# PRODUCT CHANGE NOTIFICATION

## MAGNETICS

### Select Bourns® Model 8100 Series Common Mode Inductors and Model 2100LL, 2200LL and 2300LL Series Toroid Inductors

*Added Laser Marking Method*

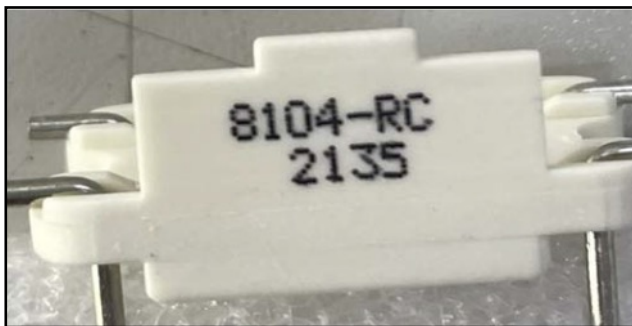
Other Model 8100 Series Common Mode Inductors and Model 2100LL, 2200LL and 2300LL Series Toroid Inductors with part numbers not listed above will continue to be produced with the current ink marking method. The combined laser marking and ink marking processes will increase the production rate of the Model 8100 Series Common Mode Inductors and Model 2100LL, 2200LL and 2300LL Series Toroid Inductors.

The form of the inductors with the laser marking will change compared to the inductors with ink marking. The function and fit of the inductors with laser marking will remain the same. The quality and reliability of the inductors with laser marking should be improved as a result of higher permanency of the laser marking.
